State Highway Commission of Kansas

SUBJECT: Supplementary Underdrain Report on Construction
Project 16-75 K-1165 (3) K-13, West Thru Olsburg
Pottawatomie County

SUBJECT: Revised Underdrain During Construction
Project No. 16-75 K-1165 (3) (Portion of Project Only)
Pottawatomie County K-13, West Thru Olsburg

SUBJECT: Supplementary Report
Underdrains and Unstable Material
Project 16-75 K-1165 (3) K-13 West Thru Olsburg
Pottawatomie County
Part I

PLAN

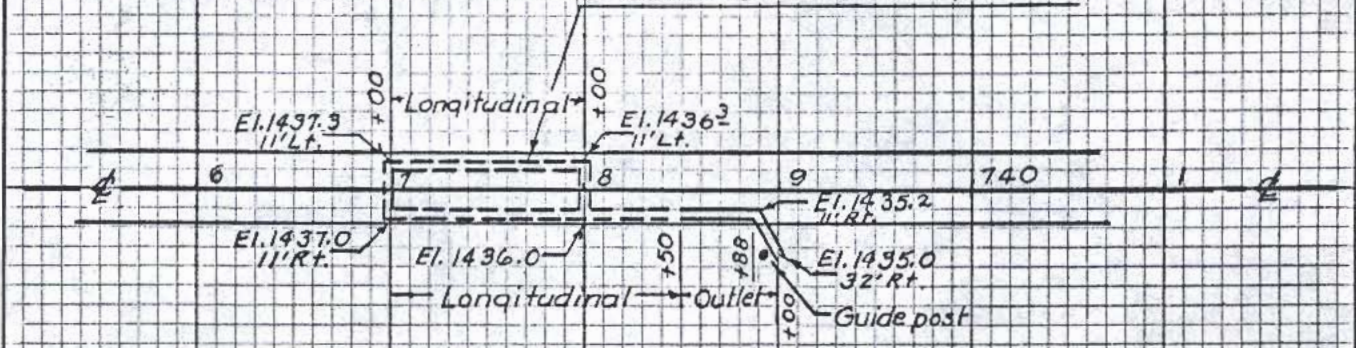
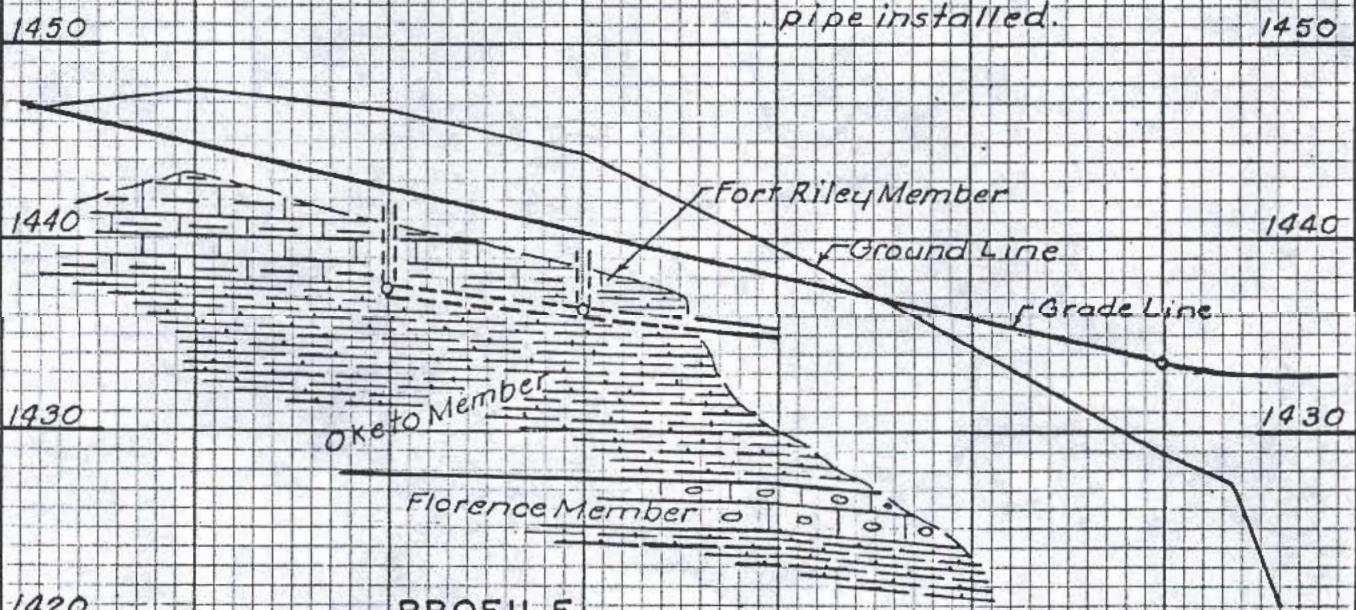
At the request of the Resident Engineer, George Davis, the area between Station 736/00 and Station 739/00 was investigated after the cut section was open to see if underdrainage would be desirable. It was found that there was a groundwater movement at the base of the Rimrock zone of the Fort Riley Member. The enclosed underdrain layout will intercept this groundwater movement.

The mantle-limestone contact as shown on the Cross sections through this location was shown too low. A small amount of rock excavation was encountered. The groundwater movement had caused some of the underlying bedrock to become badly weathered and soft. A small amount of special subgrading appears to be in order at this location.

Sta. 737+00 to Sta. 739+00
 Construct underdrain
 6" Type B, F, H or L 294 Lin. Ft.
 6" Type A, G, K or M 67 Lin. Ft.
 Outlet Guide Post 1

PLAN
 Scale: 1"=100'

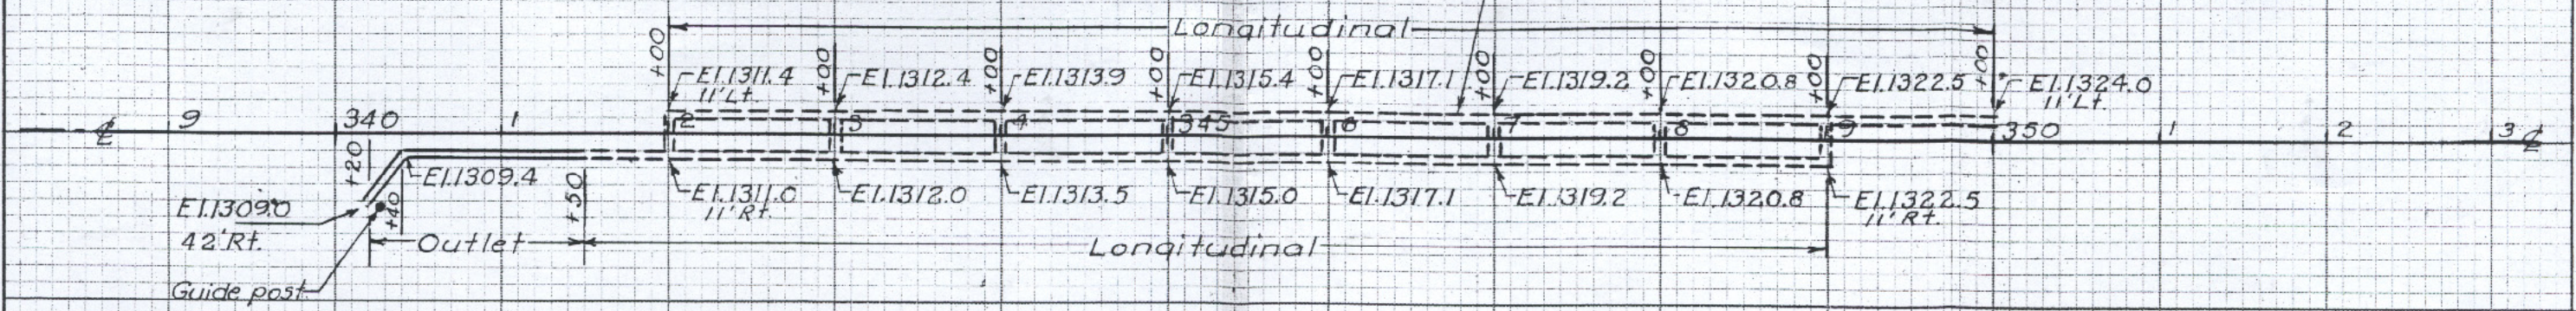
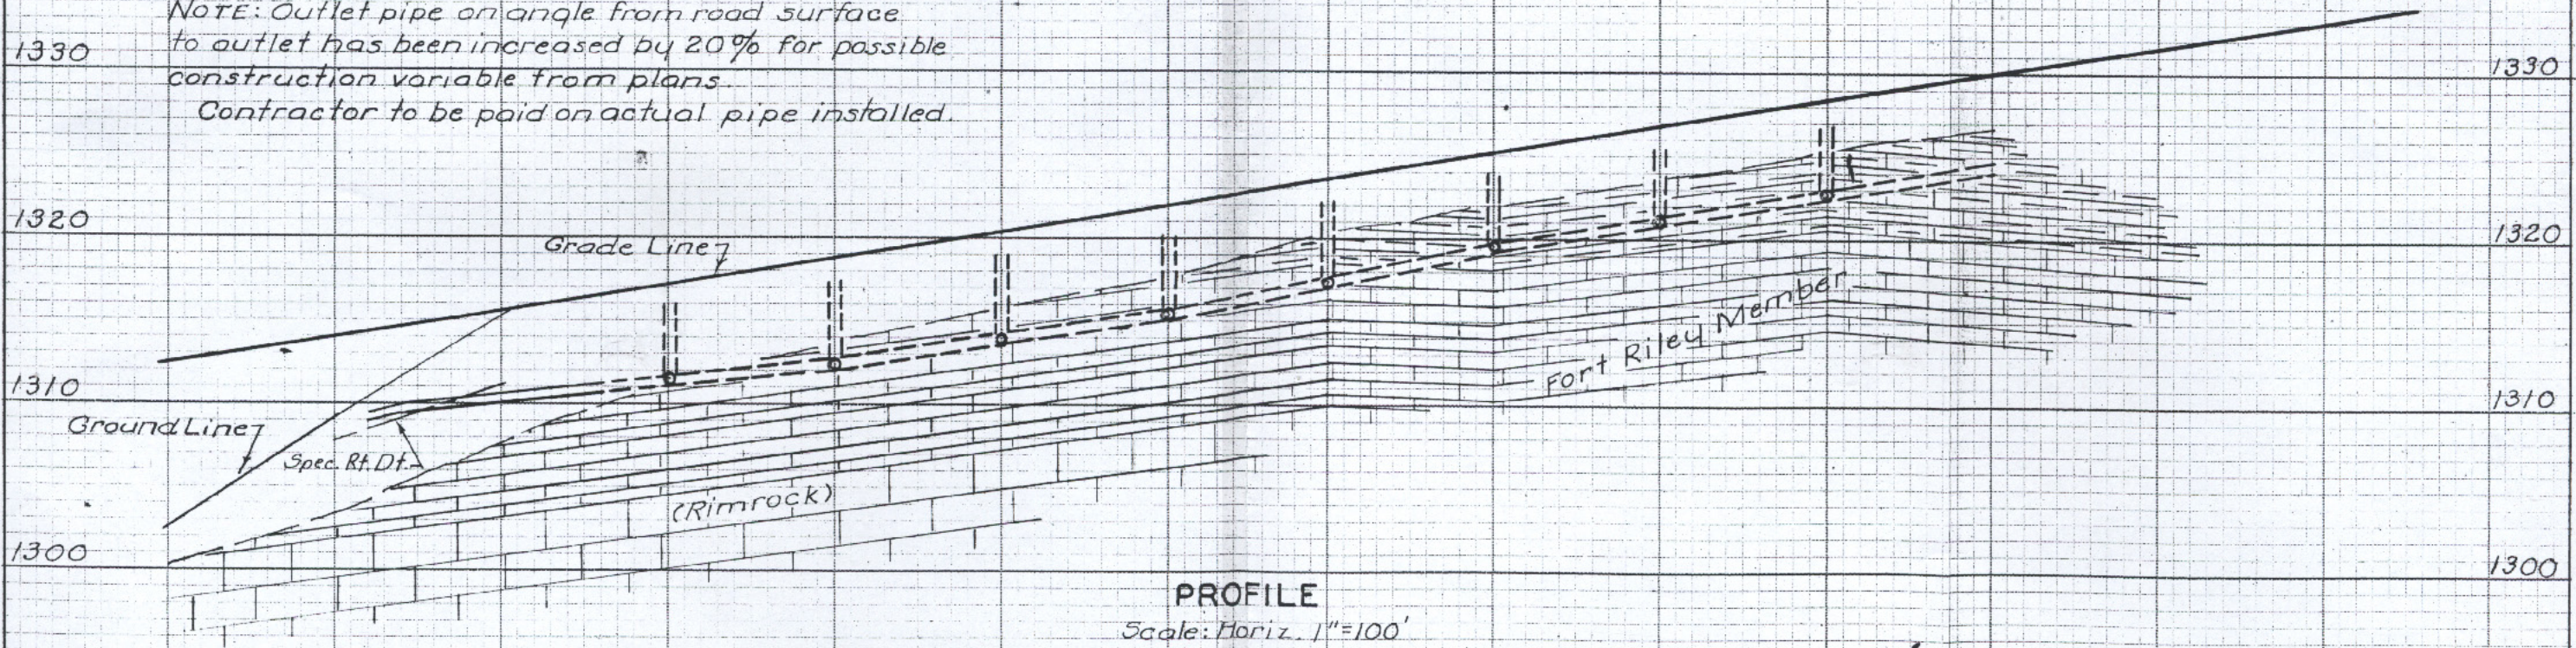
The Fort Riley Limestone is carrying a large quantity of groundwater at this location. The groundwater had caused deterioration of the shaly Fort Riley Limestone between Station 342/00 and Station 346/00. This deterioration created a soft unstable condition and subgrading was recommended. Throughout most of this location the special subgrading was at or below ditch level. The special subgraded area was backfilled with Fort Riley Limestone and Clay.

The original underdrain did not properly intercept the groundwater, therefore, it had to be modified. A lateral was added at Stations 346/00 and 348/00 to create a "stair step" type underdrain. The longitudinal section of this underdrain was continued between Station 345/00 and 346/60 to the left of centerline in order to intercept the moving groundwater in this location.

Between Stations 342/00 and Station 345/00, in the special subgrade area mentioned above, the left longitudinal was continued and two laterals were added to protect against induced surface water. The outlet has been moved back to Station 340/20 because of a constructed entranceway that centers on Station 340/00 to the right. The right ditch was special throughout this location enabling the special subgraded area to drain.

The changes in the original underdrain result in an overrun of 438 feet of perforated pipe and 9 feet of outlet pipe. The new underdrain is enclosed.

Sta. 340+20 to Sta. 350+00
 Construct underdrain
 6" Type B, F, H or L 1726 ft.
 6" Type A, G, K or M 154 ft.
 Outlet Guide post 1

PLAN VIEW
 Scale: 1" = 50'

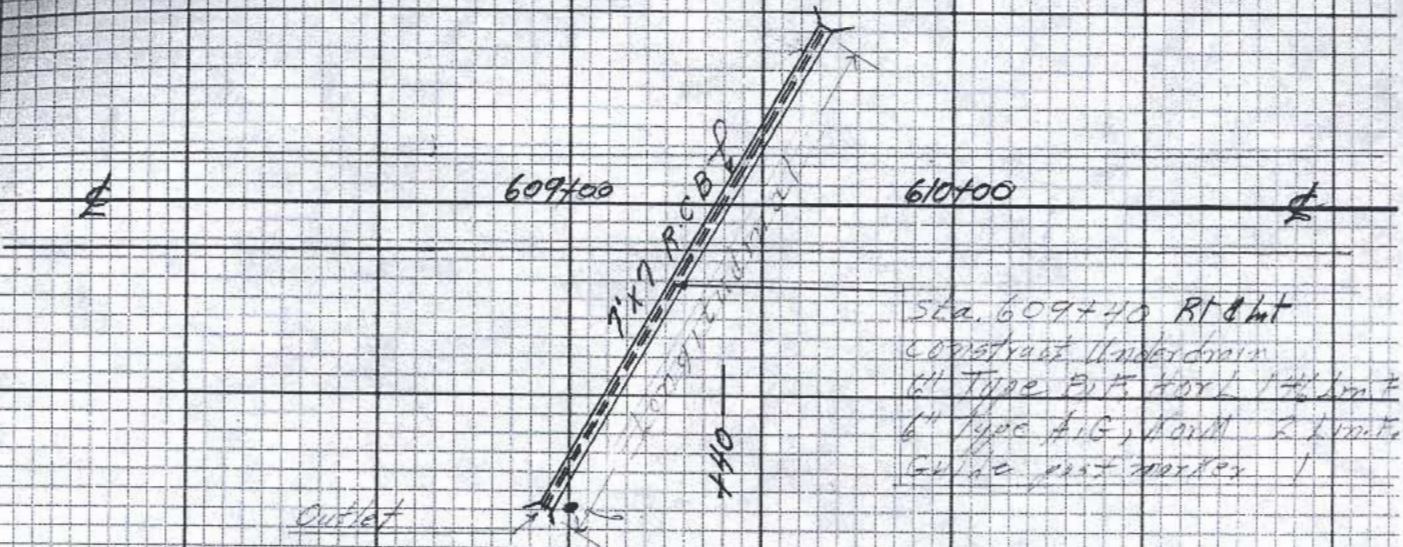
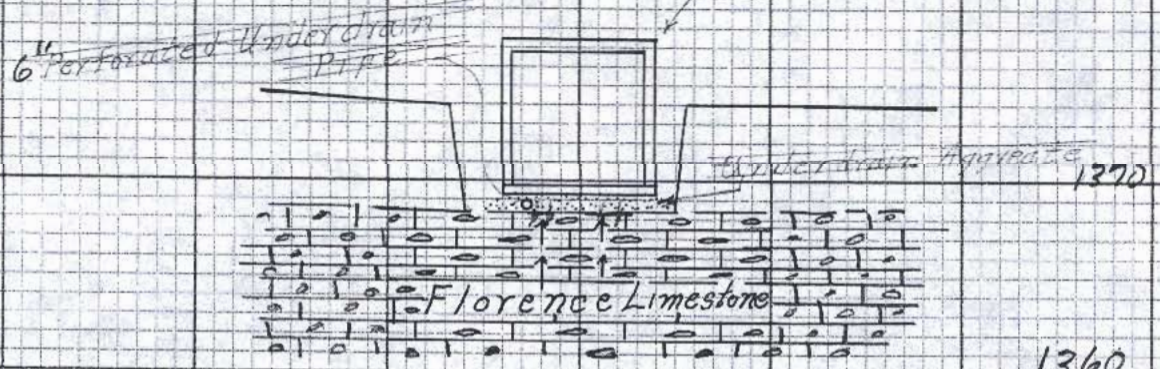
During the excavation for the 7 x 7 x 146 foot R.C.B. at this location groundwater was encountered flowing up out of open channels in the Florence Limestone. This water is under a hydrostatic head and produces a fair quantity of water. In order to protect the fill section from this groundwater and to allow it to flow out without any restrictions; it is recommended that the saturated material that would lie between the R.C.B. and the Limestone be removed and replaced with underdrain aggregate. The average thickness of this aggregate will be approximately 1 foot. A perforated underdrain pipe should be placed in the aggregate beneath the box to the up station side. The strongest flow of groundwater is coming in from the up station side. The underdrain pipe should

Sta. 609+40 Right
 construct Underdrain
 6" Type B.P. for 1st 1/2' from E
 6" Type A.G. for 1st 1/2' from E
 (Leave rest rocky)
